Access Compliance Report

Public Rights-of-Way

(Curb Ramps)

Intersection ID: 28446	Main Street: SHINING_OAK_LN	Cross Street: SUMMER_CREEK_LN	Location: NE
ADA ID: B842C0A8EF4B	Ramp Type: Para	Initial Pass/Fail: Fail	Overall Compliance: No
Severity Score: 12.5			
Codes/Mitigation Info/Possible Solution		Field Measurements/Component Compliance

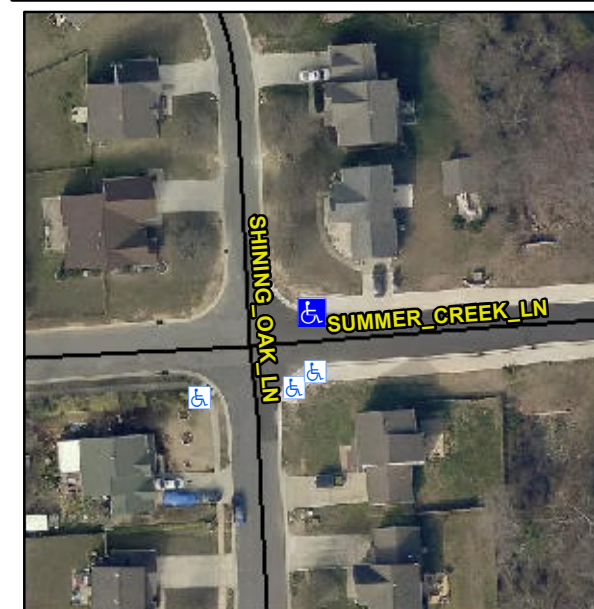
RT RP < 5%

R304.3.2

Remove & Replace Entire Ramp.
